Top Cowl Unlatching – 1989 and 1990 Mariner/Mercury 135-200

To prevent top cowl from unlatching when outboard is operated on rough water, it is necessary to install items listed. Earlier models require redesigned front cowl latch, longer safety latch pin and washer on both rear latch hooks. Later models require washer on both rear latch hooks. Models S/N 0C273935 and above have all items installed.

Figure 1. Front Cowl Latch

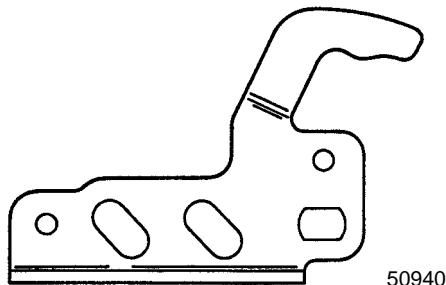
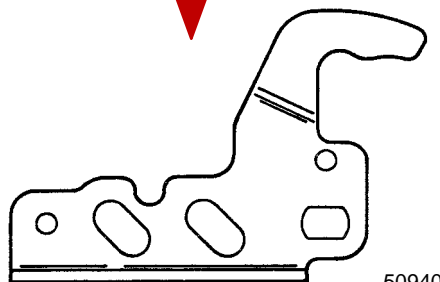
Qty. 1 P/N 813076--2 Front cowl latch

Previous Latch P/N 813076--1

New Latch P/N 813076--2

Figure 2. Front Latch Assembly

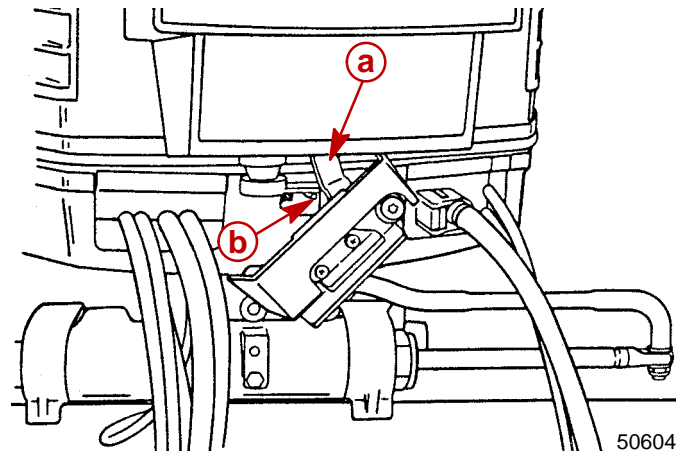
Install: (Figures 2 and 3)

Qty. 1 P/N 17-815296 Pin – safety latch

Previous P/N 17-813930 - 7/8 in. (22mm) long

New P/N 17-815296 - 1 in. (25mm) long

Figure 3. Rear Latch Hook Assembly

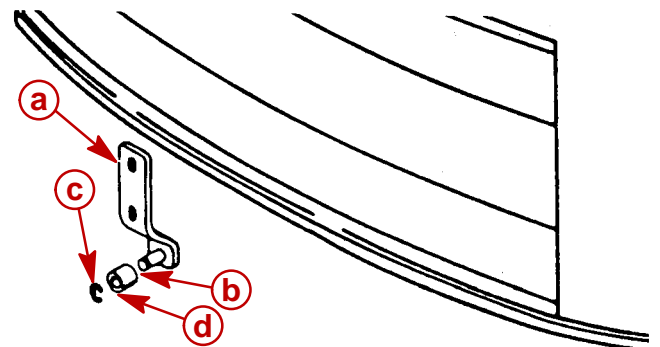
Install: (Figure 3)

Qty. 2 P/N 12-36001 Washer – rear latch hook

d - Add Washer P/N 12-36001 Between Roller and "E" Ring
